CONDON WIND PROJECT

Final Environmental Impact Statement
DOE/EIS-0321

Condon Wind Project Final Environmental Impact Statement (FEIS) (DOE/EIS-0321)

Figure 2.1-3
Turbine Features, 600-KW

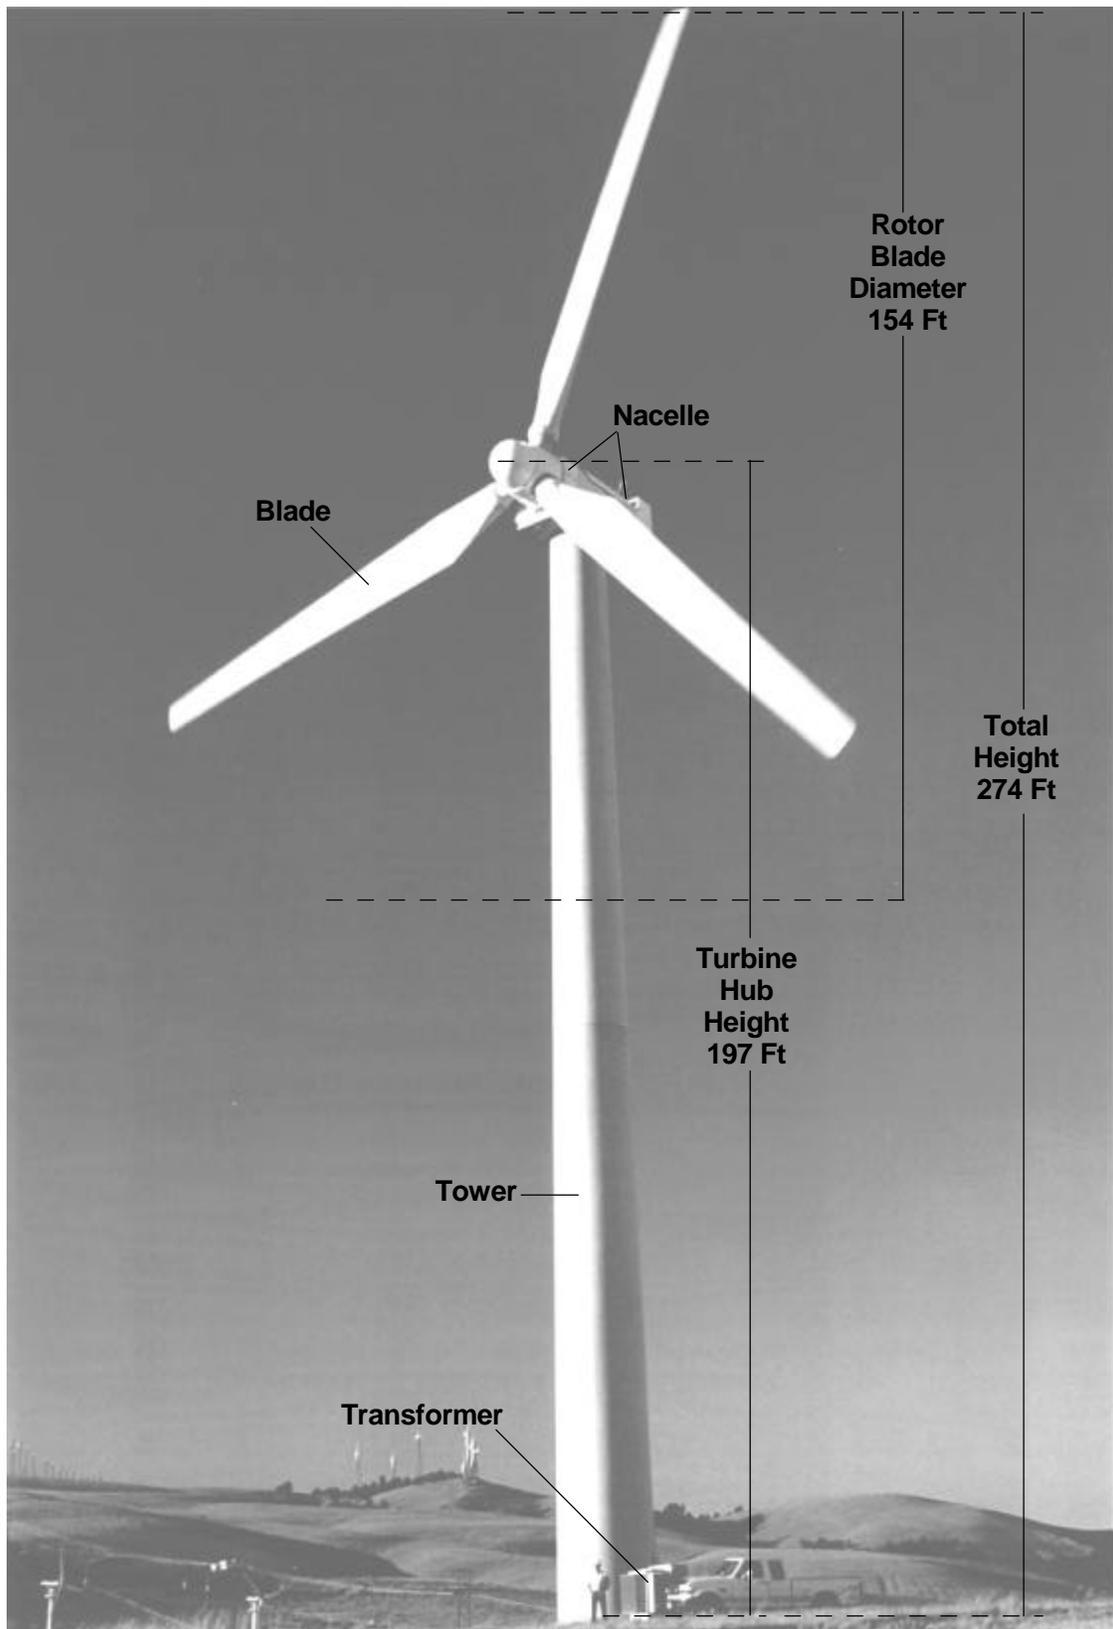
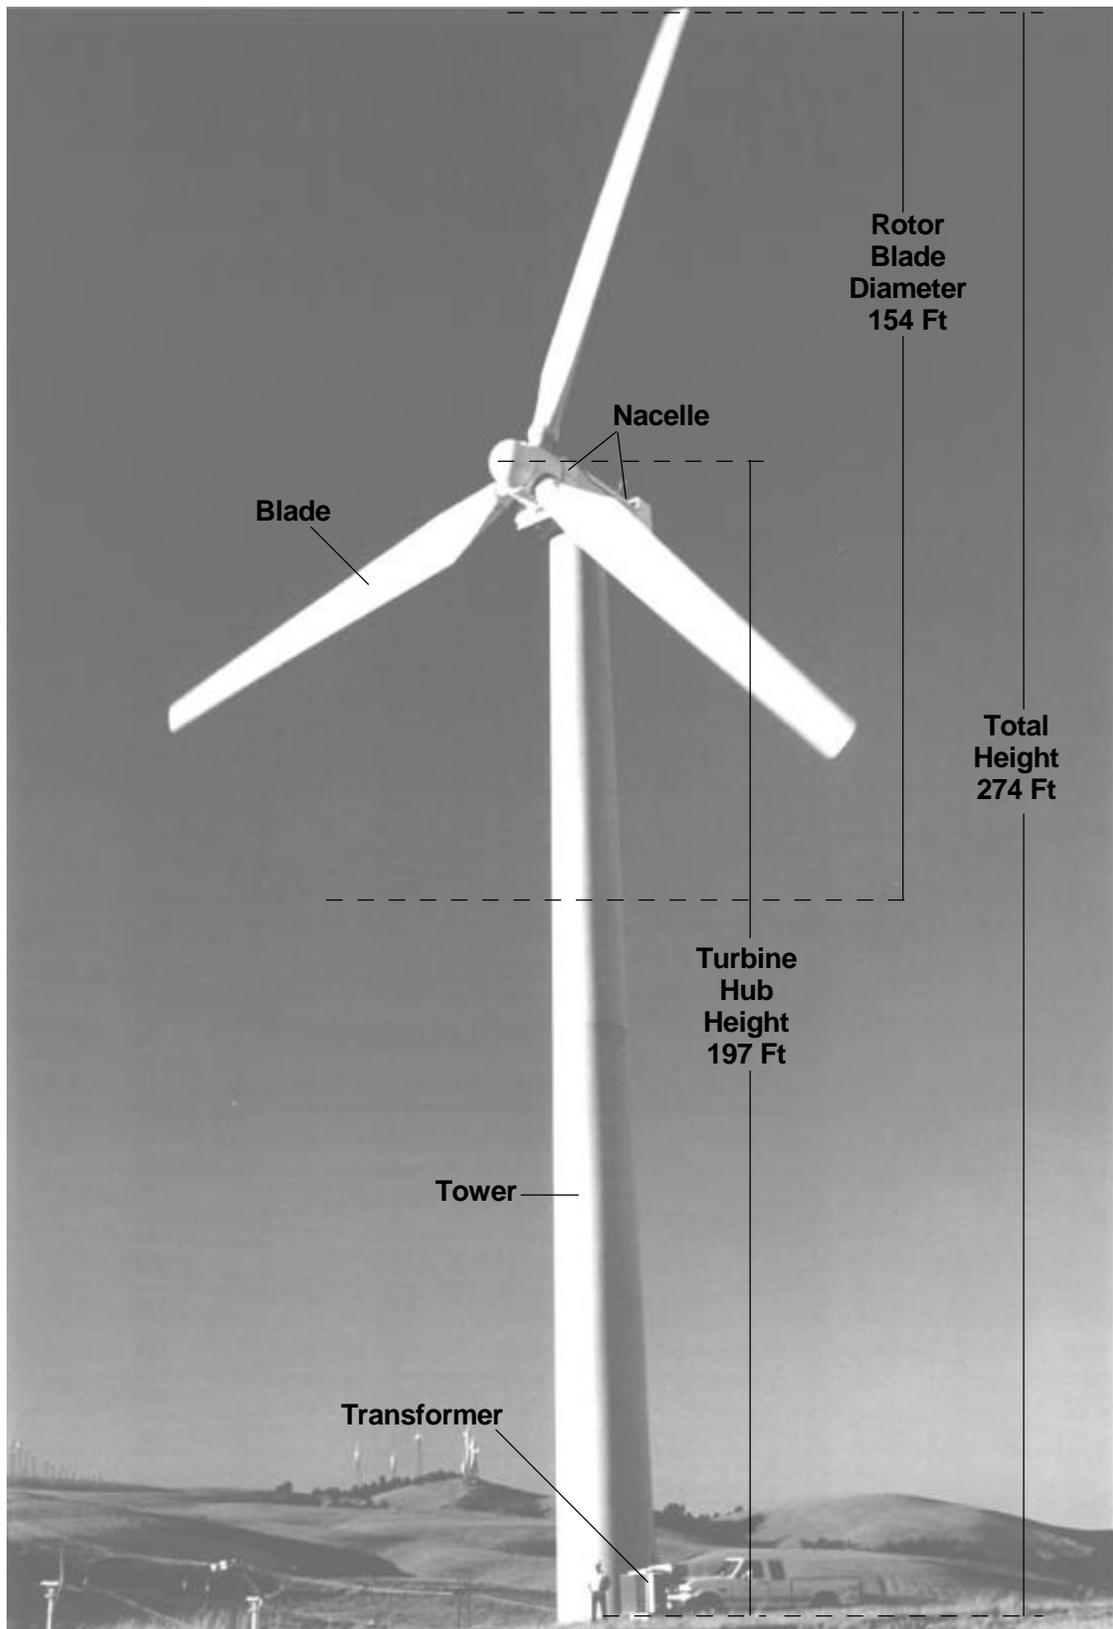
[AMEND DEIS] Figure 2.1-3—Turbine Features, 600 kW, replace with figure that follows this page.
